# M9018A-04

## S E R V I C E N O T E

### M9018A 18 slot PXIe Chassis

### M9018A Serial Number Does Not Display in Agilent Connection Expert

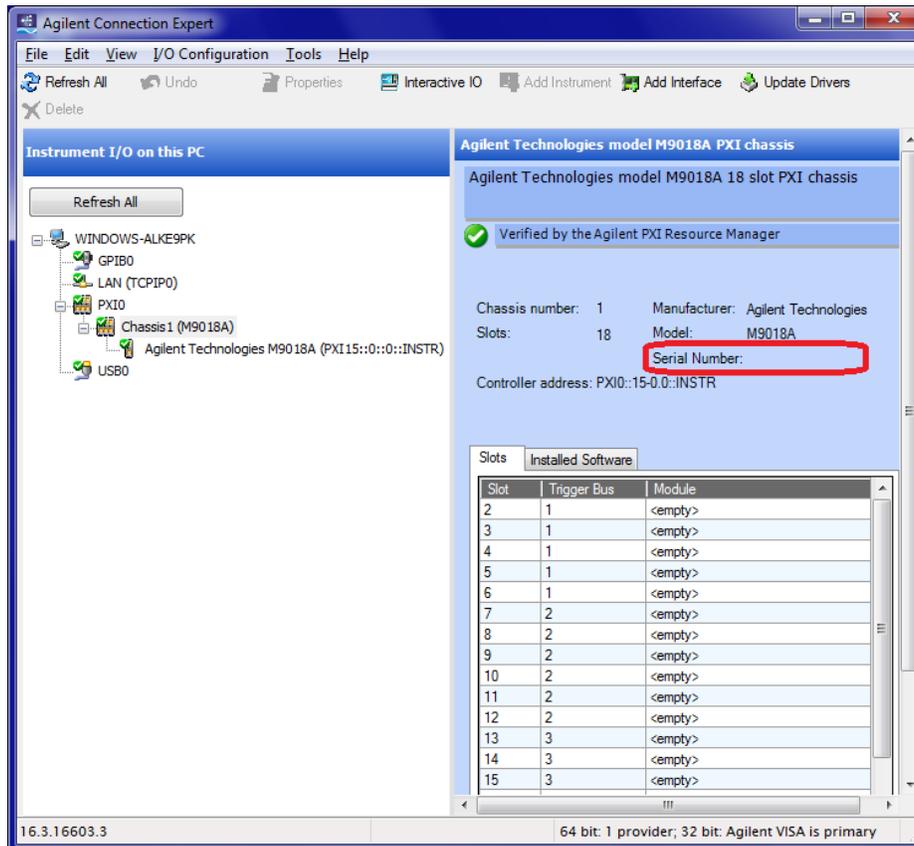
It has been found for the affected M9018A described above with the configuration setting of:

1. “2-Link Configuration: 2x8” and using the Agilent M9036A PXIe Embedded Controller
2. Or “4-Link Configuration: 4x4” and using 3<sup>rd</sup> party embedded controller

That the M9018A chassis serial number does not display when opening Agilent Connection Expert. See picture below:

If the symptom is observed, contact Agilent Service for repair.
